Subject: Transmittal of Revision 1 To Service Bulletin Number

ENGINE - FUEL AND CONTROL - SELECTIVE REPROGRAMMING OF THE DATA ENTRY PLUG ASSEMBLY

April 16/98 Revision 1 July 29/98

V2500-ENG-73-0132

Data Entry Plug Assembly Figure 2

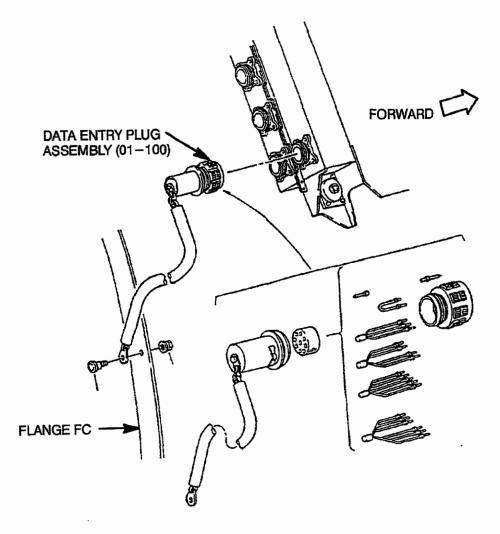
- A. Remove the Data Entry Plug by the procedure given in Reference (2), Chapter/Section 73-22-35, Repairs, VRS3500.
- B. Disassemble the Data Entry Plug Assembly, PN 2A3106, Reference (1), Chapter/Section 73-22-35, Figure/Item No. 01-100) by the procedure specified in Reference(2), Chapter/Section 73-22-35, Repairs, VRS3500 and Figure 2.

- D. Modify the Data Entry Plug Connector by the procedure specified in Reference (2), Chapter/Section 73-22-35, Repairs, VRS3500.
- E. Assemble the Data Entry Plug Assembly by the procedure specified in Reference (2), Chapter/Section 73-22-35, Repairs, VRS3500 and Figure 2.

Identification Of The Data Entry Plug Assembly To the New Part Number Figure 3

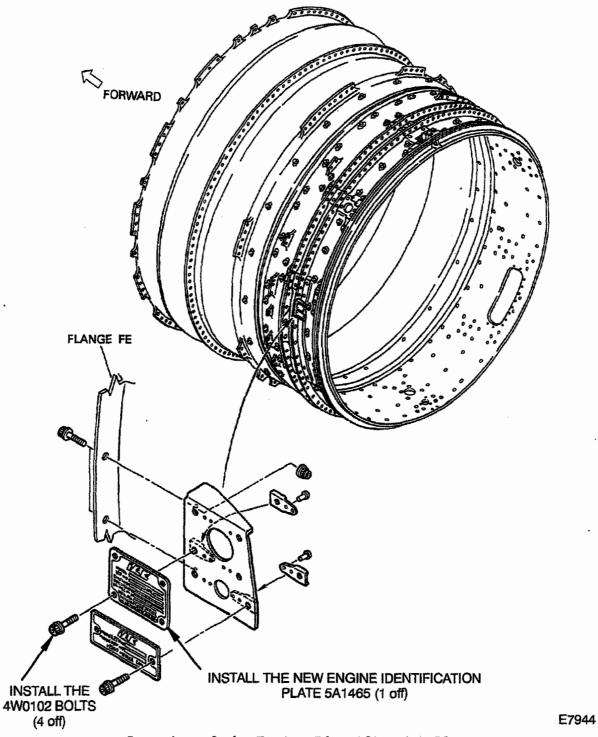
- G. Mark the Data Entry Plug Backshell with the new EPR Mod by the procedure given in Reference (3), Chapter/Section 70-09-00, Marking of Parts and Figure 3. Use the vibration peen method.

Location of the Engine Identification Plate Figure 4

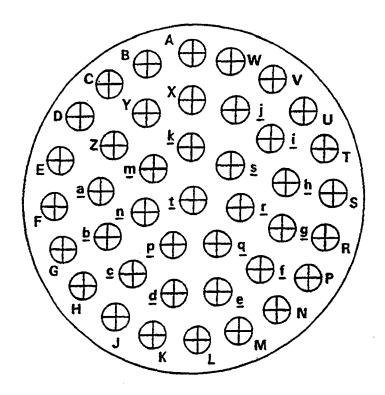
- H. Install the Data Entry Plug by the procedure given in Reference (2), Chapter/Section 73-22-35, Repairs, VRS3500.
- I. Mark the Engine Identification Plate with the new EPR Mod by the procedure given in Reference (3), Chapter/Section 70-90-00, Marking of Parts and Figure 4, Using the vibration peen method; or install a new Engine Identification Plate, PN 5A1465, Reference (1), Chapter/Section 72-32-85, Figure Item No. 03-120, and Figure 4 as follows:

- (1) Remove the four bolts (4W0102), that hold the Engine Identification Plate to the bracket.
- (2) Give the old Engine Identification Plate to your IAE Representative.
- Get the new Engine Identification Plate from your IAE Representative.
- Install the new Engine Identification Plate with the 4W0102 bolts (4) (4 off).
- Torque the bolts between 32 to 36 lbfin (3.61 to 4.07Nm).
- J. Check the data entry plug wiring by interrogating the MCDU and comparing the output EEC CONFIGURATION information output to the Data Plate information, when the EEC and DEP are installed on the aircraft. Use the procedure specified in Reference (2), Chapter/Section 73-22-35, Installation and Figure 6.

Contact Hole Locations Figure 5

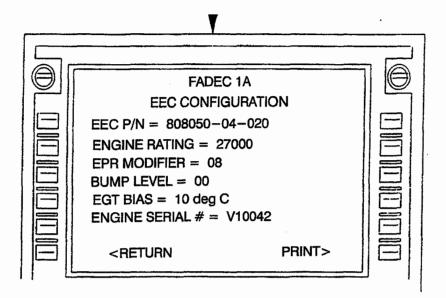
- C. Make two copies of Figure 5, Contact Hole Locations.
  - (1) Find the Current EPR Mod No. and the Corrected EPR Mod No. for each specific engine from Table 1.

- (2) Mark the existing jumper connections from the Data Entry Plug Connector on one copy of the figure.
  - (3) Find the jumper pin connections, from Table 2, for the Current EPR. Mod No. and highlight these on the copy made in C. (1).

- (4) Find the jumper pin connections, from Table 2, for the Corrected EPR Mod No. and highlight these on the second copy of the figure.
  - (5) Determine the jumper pin changes required from these two copies, for the target EPR Modifier, and any new jumpers needed, (Reference (1), Chapter/Section 73-22-35, Figure/Item No. 01-100), and Figure 2.
